ADDENDUM NO. 01

EIFS EXTERIOR WALL REPLACEMENT
ED EDELMAN
CHILDREN'S COURT

JCC PROJECT NUMBER: FM-0046136

August 15, 2017

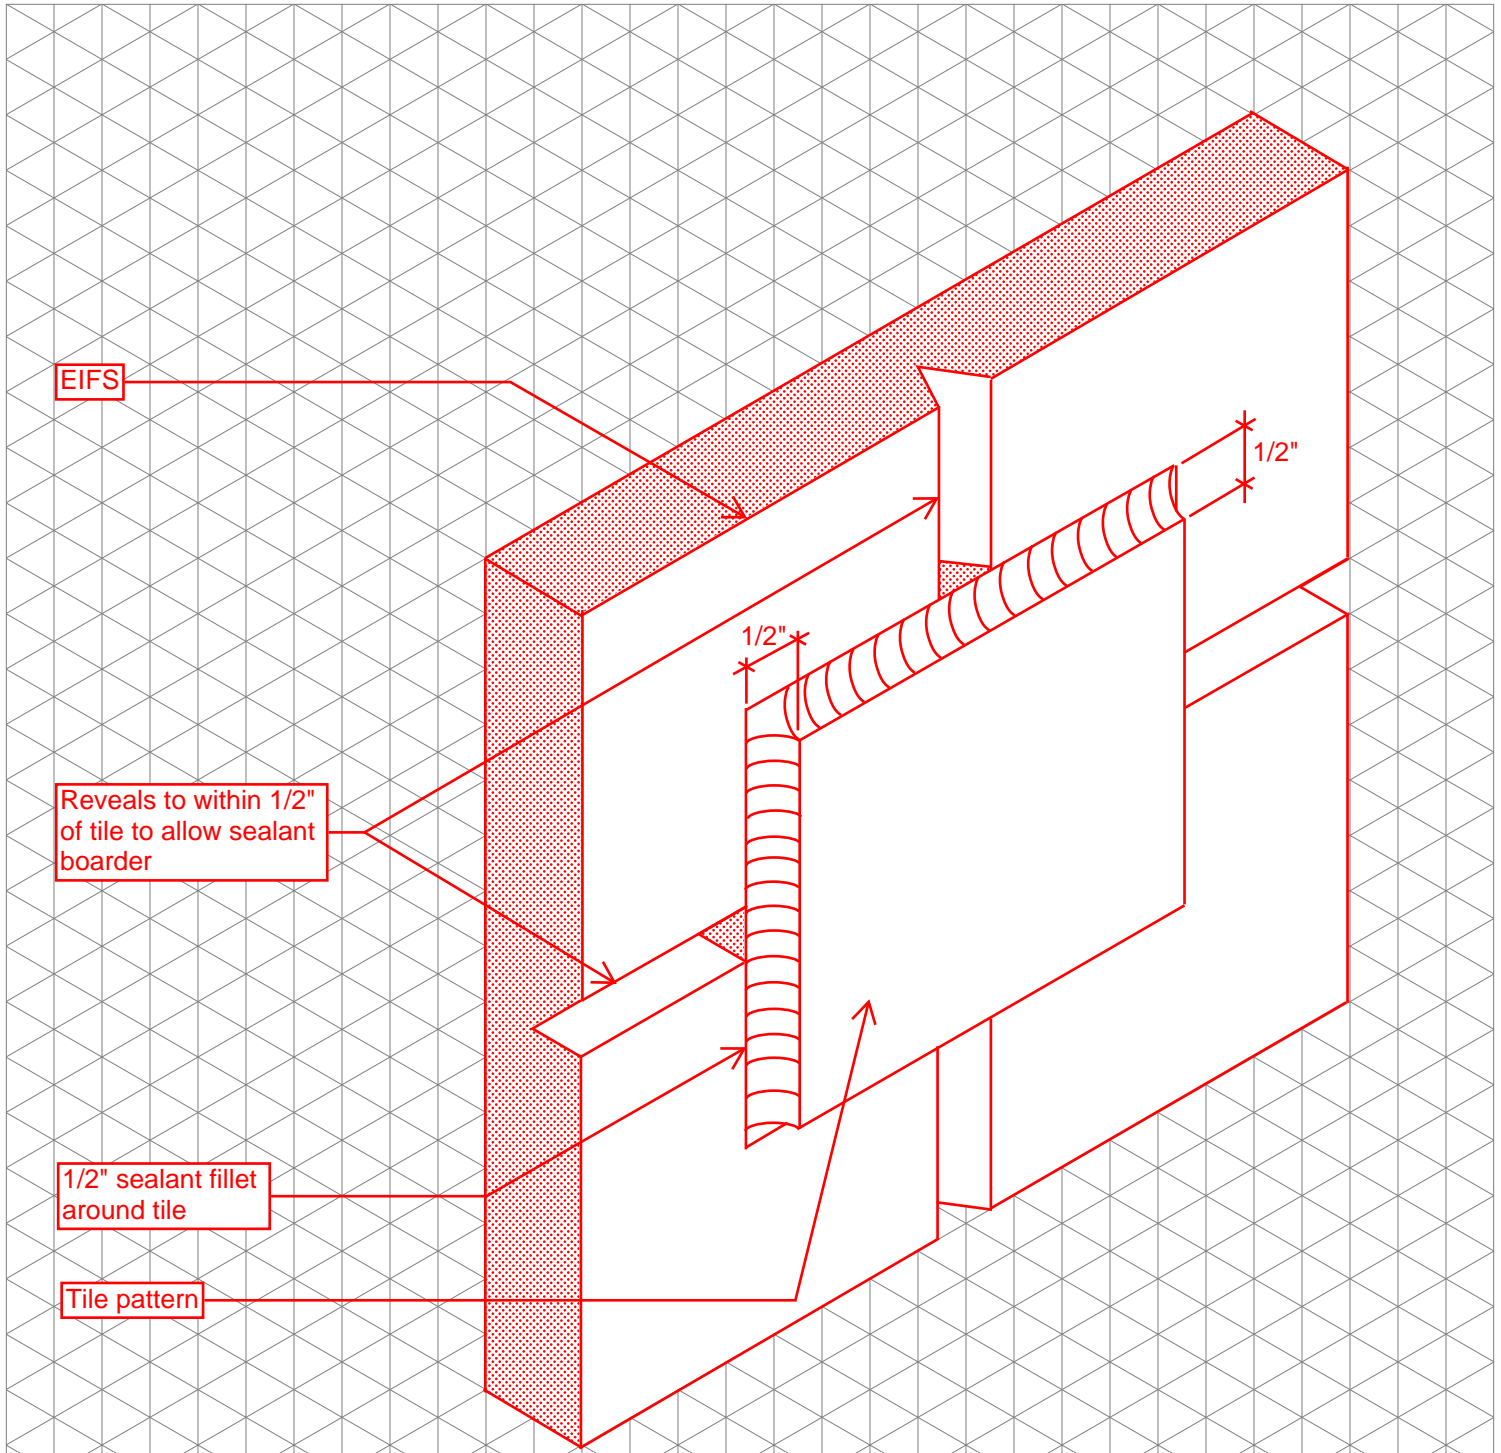
Q #	Questions	RFQ Reference (Document & Page-Section-Item)	Answers
19	<p>During the job walk it was notice there are several existing ladders mounted to the existing EIFS wall finish. What to do?</p>	<p>General Question</p>	<p>If not identified on the plans or specified in the specifications, the contractor shall remove all existing ladders to apply the specified EIFS wall finish material. Once the EIFS wall finish material is completed the contractor shall re-install all surface mounted ladders back to their original locations. Reuse (if not damaged during removal) existing anchorage bolts. If damage replace with matching anchorage bolts matching same size and length. All new anchorage bolts, nuts and washers shall be galvanized. When reapply the existing ladders, secure to the new EIFS wall finish snugly (do not over tighten screws/bolts) so as not to damage or cause cracking to the EIFS wall finish. However the ladders need to be secured according to the original anchorage requirements or to OSHA strict standards. Provide approved sealant at all anchor points/location and around entire surface angle support brackets that make contact to the new EIFS wall finish.</p>
